ADDENDUM NUMBER 02 TO THE BID DOCUMENTS

**BID DOCUMENT: 17/18 MB7
I21-35617 - Organic Farm Classrooms
College of Marin – Indian Valley Campus**

Addendum Date: 23 February 2018

SHEET NO:
A2.01

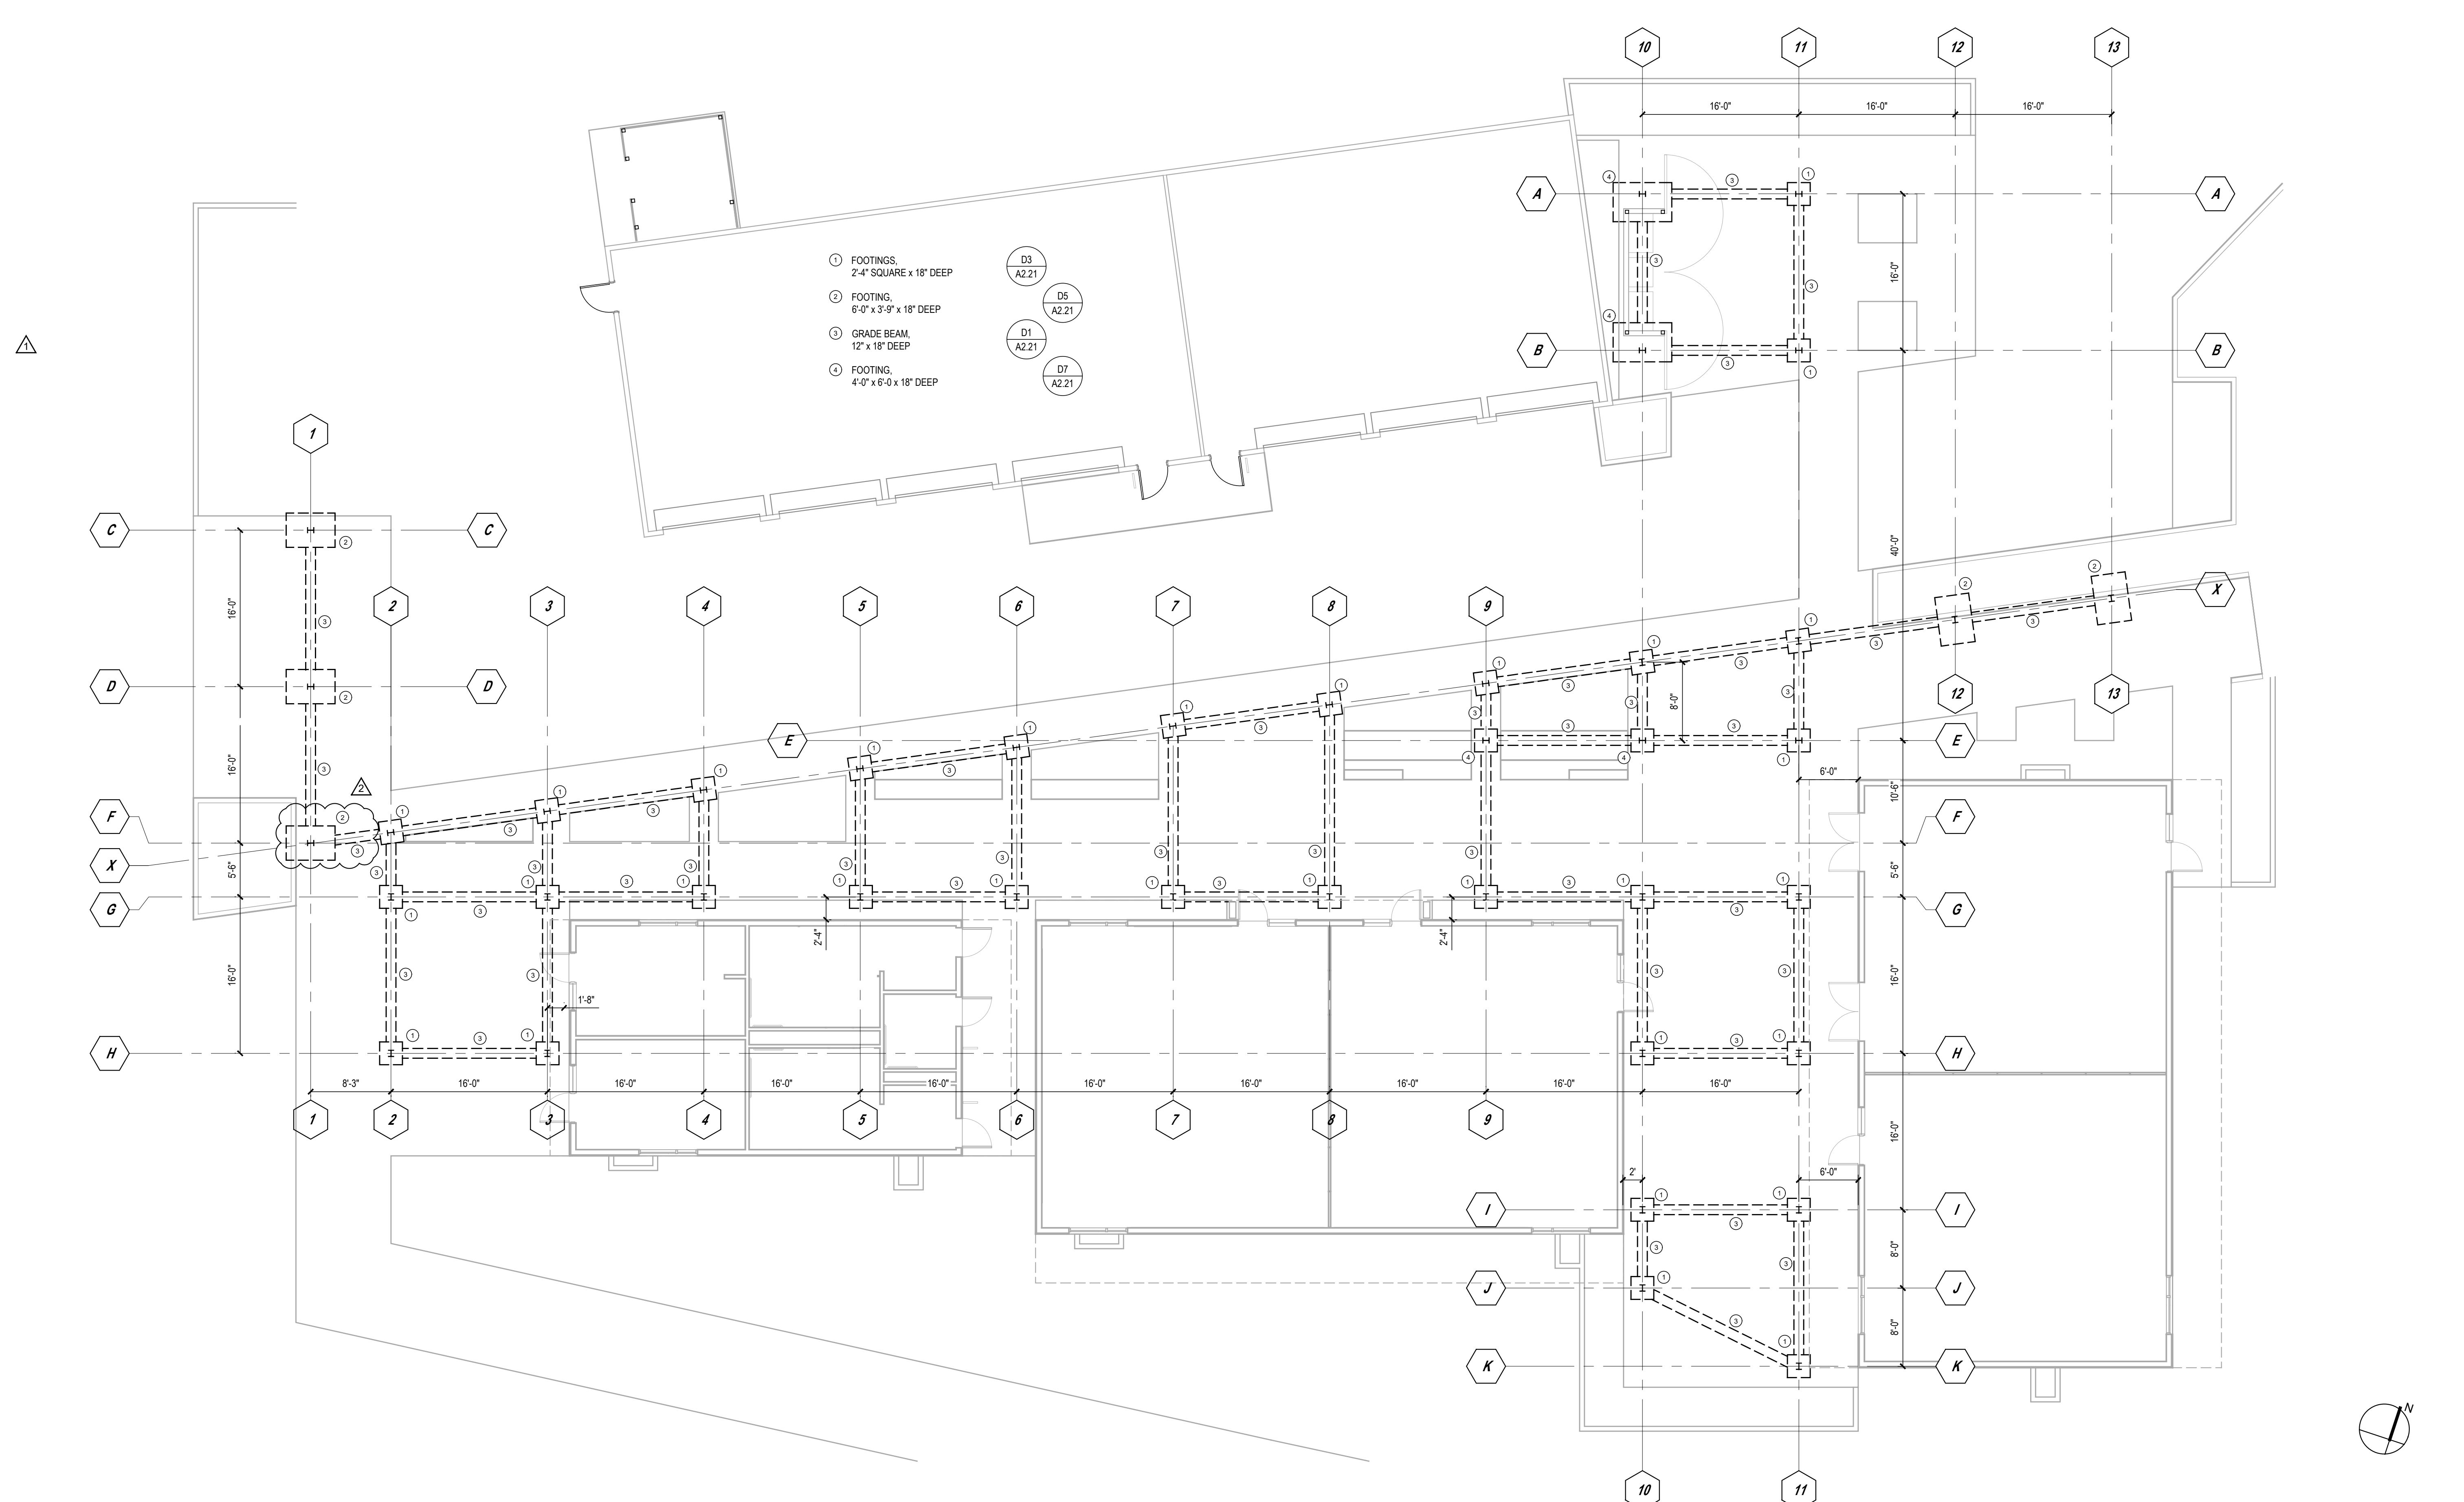
- Reinstate DSA approved comments.

A2.02

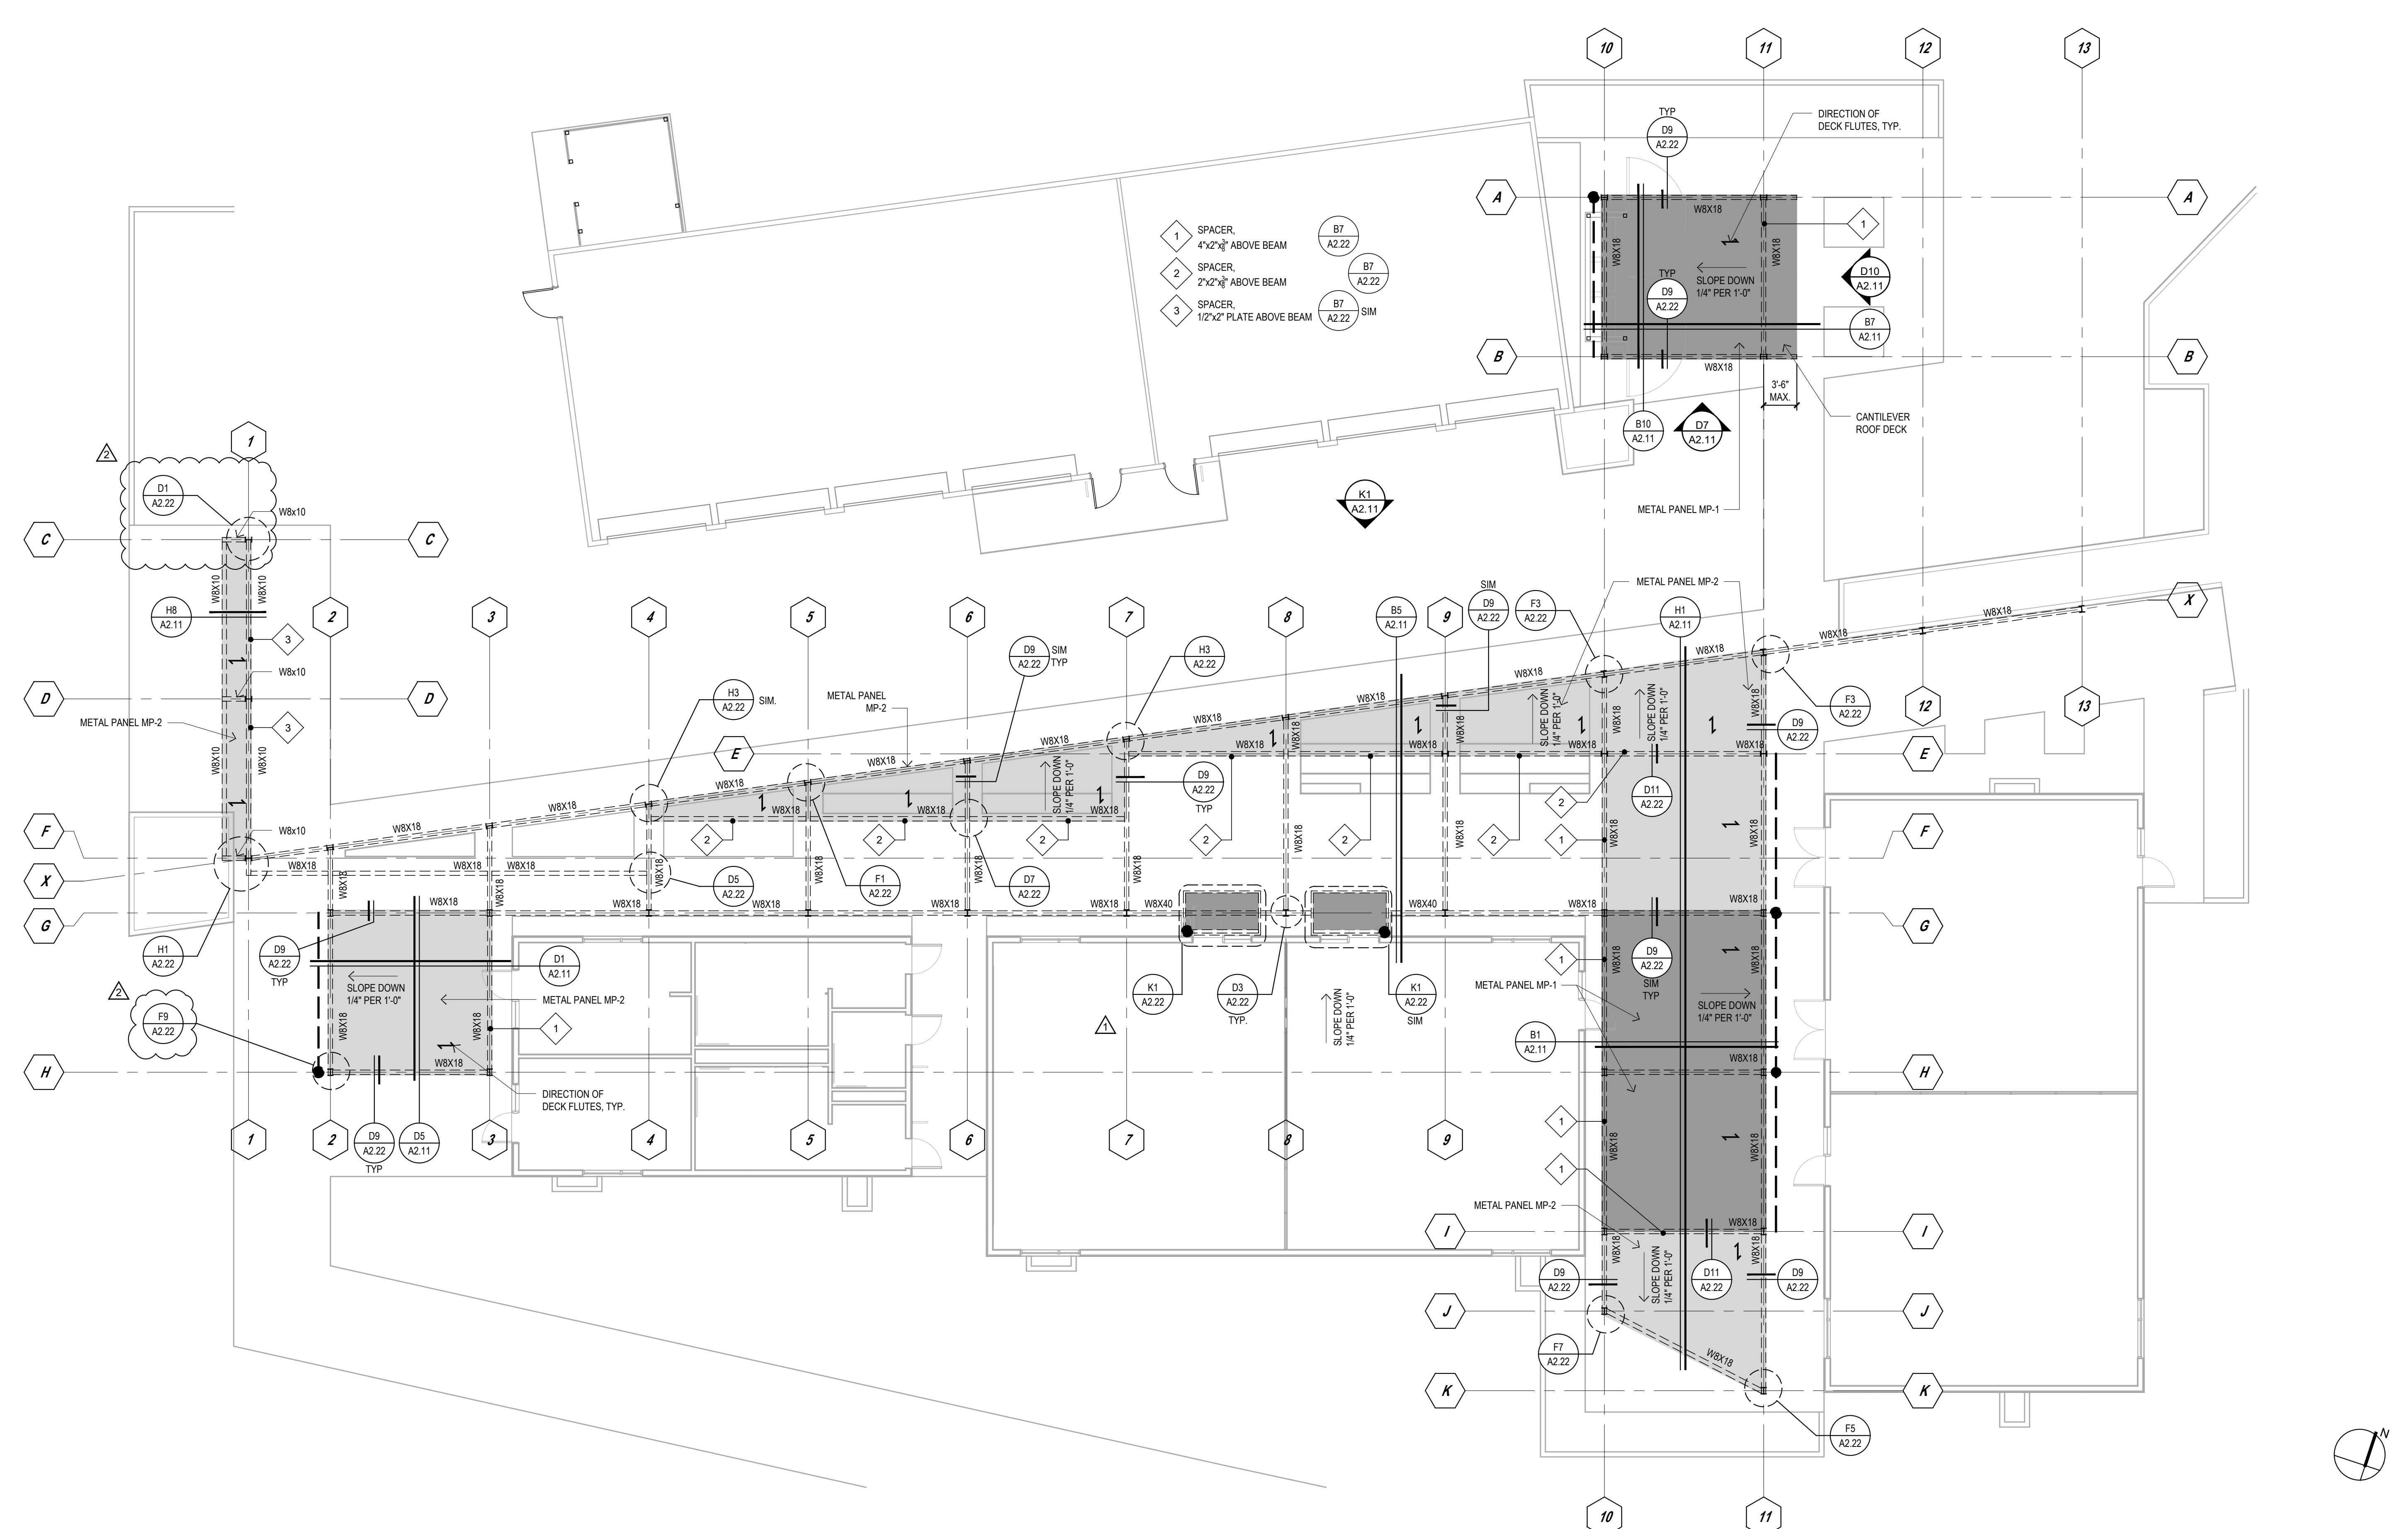
- Reinstate DSA approved comments.
